**REFERRAL COMMENTS**

Variance (Area): V-18-26  
Address: 108 Woodside Dr, Syracuse, 13224

Request:  
Waiver of front yard setback and driveway width.

Project Site: 108 Woodside Drive, Syracuse NY 13224

**1 SITE PLAN - DRIVEWAY LAYOUT**  
SCALE: 1/8" = 1'-0"

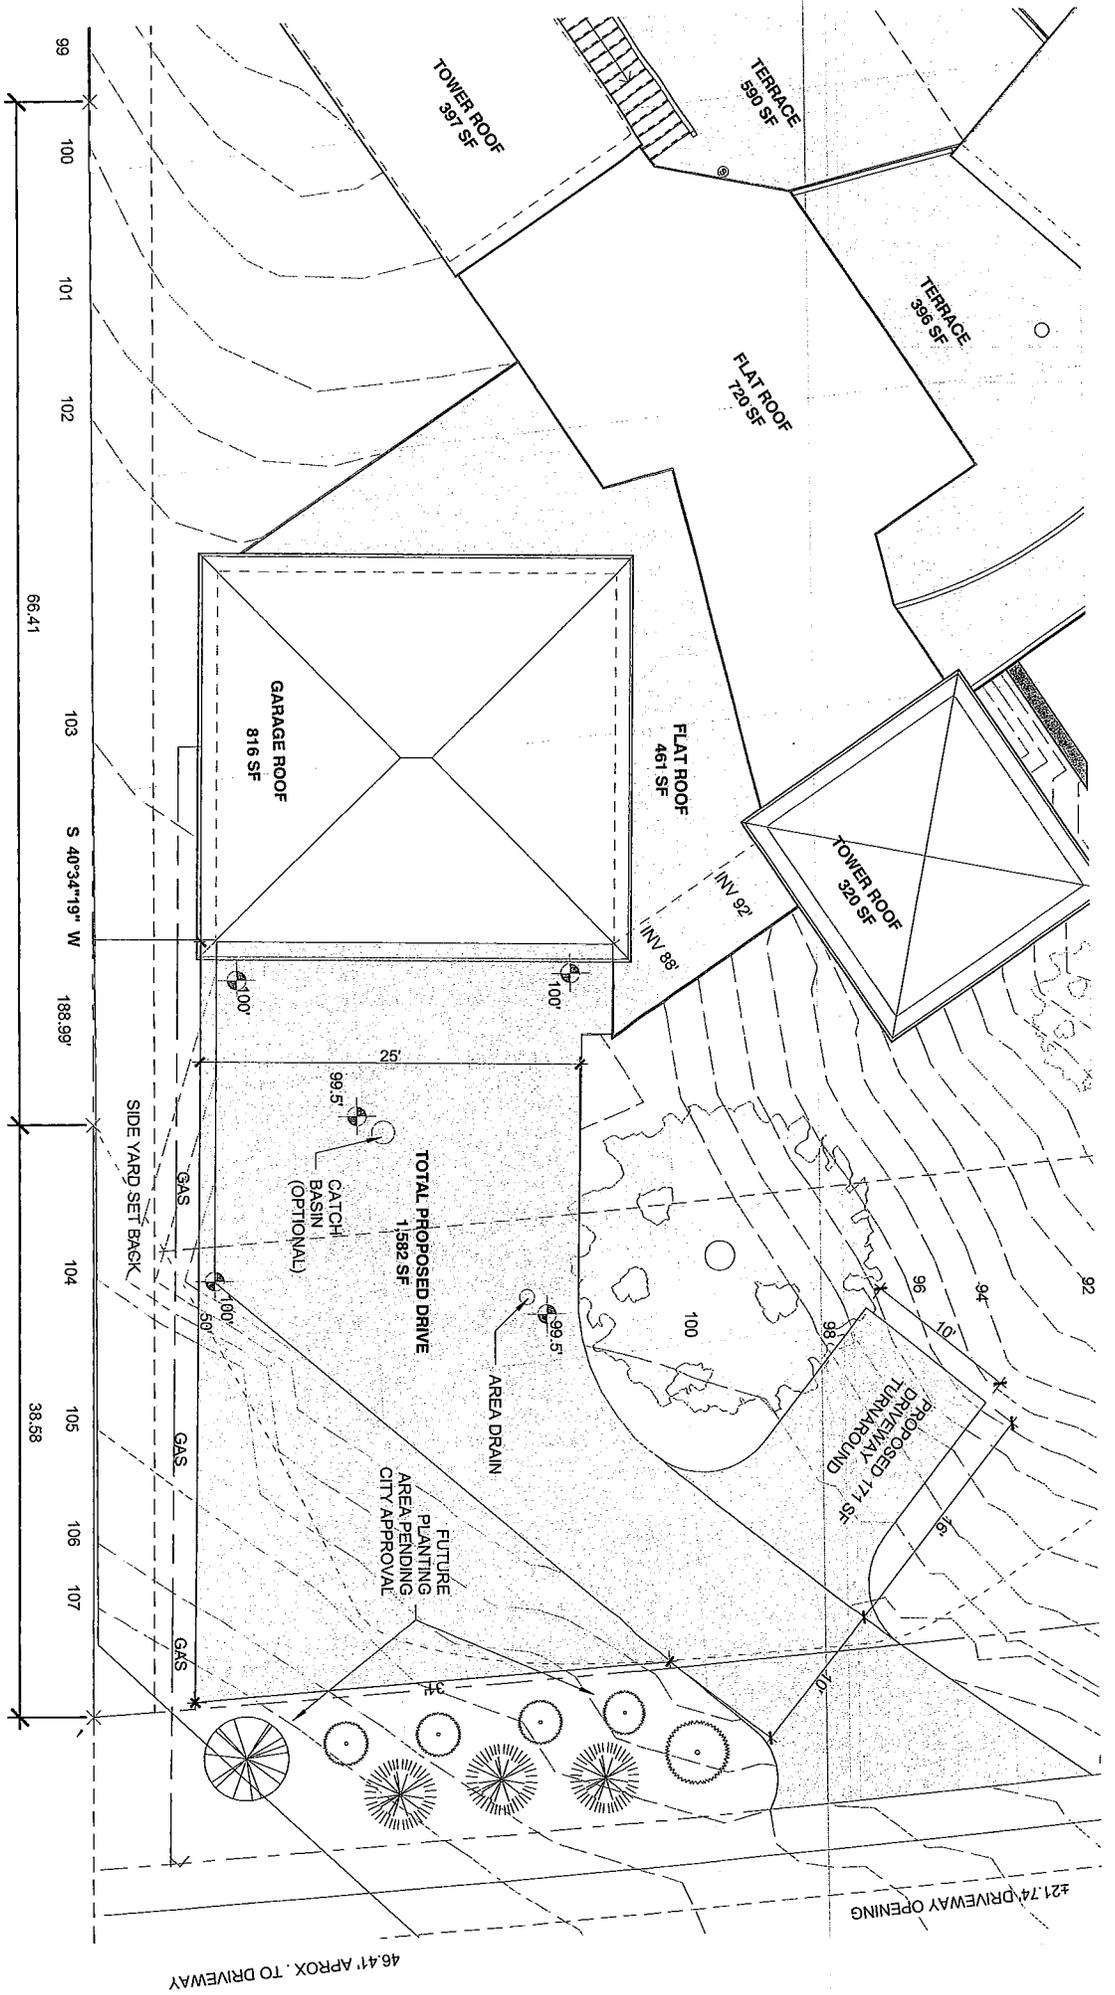
Approval	Status	Status Date	Reviewer	Comments
DPW Street Repair - Zoning	Internal Review Complete	08/11/2018	Kevin Hunter	No Concerns
DPW Commissioner - Zoning	Internal Review Complete	08/14/2018	Martin Davis	Comply with all Bureau & Division comments. (Storm water runoff & Driveway visibility)
DPW Sewers - Zoning	Internal Review Complete	08/14/2018	Vinny Esposito	Storm water can not adversely impact adjoining properties.
DPW Sidewalks - Zoning	Internal Review Complete	08/13/2018	Chris Ettinger	no concerns
DPW Traffic Control-Zoning	Internal Review Complete	08/15/2018	Jim French	no concerns
DPW - Transportation Planner	Internal Review Complete	08/21/2018	Neil Milcarek-Burke	- Any turning movements required for safe egress should be handled in the existing large driveway area in front of the garage, not in the building setback or near ROW. - Additionally, the driveway/curb-cut is shown well in excess of City spec 12' wide for residential properties. This angled driveway was noted as a concern by reviewers on the road-cut permit.

Eng. Design & Cons. - Zoning	Internal Review Complete	08/23/2018	Alvin Chan	Why can't this driveway be perpendicular to the road? No stone apron would be allowed. Proposed driveway opening should go to the edge of pavement of the road. This is not shown as such on the plans. Is 22 foot wide driveway needed? Should there be some sort of hidden driveway sign warning drivers of the potential of oncoming cars from here? Steve Harris from City Parks is to approve any trees going in the City R.O.W. Street cut permit review and approval would be required for all work in the City R.O.W. and such work in the City R.O.W. shall be done to city standards and specifications. Create no adverse effect to adjoin properties from stormwater.

City Engineer - Zoning	Internal Review Complete	08/27/2018	Ray Wills	<p>-City Engineer Defers comment to Mapping, Design and Construction and other reviewing Depts.</p> <p>-City Engineer deferment does not render permits for any work in the ROW (i.e. Street Cuts, Encroachments etc) unnecessary. Should the project require it, the permits must be obtained in advance of work commencing</p> <p>-Review and acceptance of Project Site Reviews, Special Permits or any of the like does not absolve the applicant from the responsibility of obtaining permits for work inside the ROW (ex Street Cuts, Curb Cuts, Encroachments, Sidewalk replacement, etc....) , or where applicable obtaining a SWPPP prior to work commencing.</p> <p>-THE CITY ENGINEER DEFERRAL APPLIES TO THIS REVIEW ONLY.</p>
Eng. Mapping - Zoning	Internal Review Complete	08/08/2018	Ray Wills	No impact on Mapping Division assets. The planting plan marked as yet to be approved by the City will required an encroachment and maintenance schedule and also be designed to ensure that they will never cause a line of sight issue for cars entering or leaving the driveway for the safety of drivers and pedestrians.
